## Technical Service Bulletin

#### 64 Noise in rear door windows during operation

64 14 35 2038102/1 August 13, 2014.

**Figure 1.** Mating surface between the drive cable and the upper pulleys.

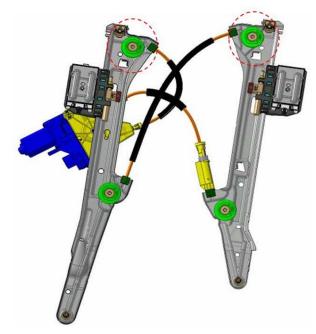
The noises arise from the mating surface between the drive cable and the upper pulleys (Figure 1). The noises may be more common in higher temperatures.

An improved rear window regulator is implemented in production.

Replace the affected rear window regulator.
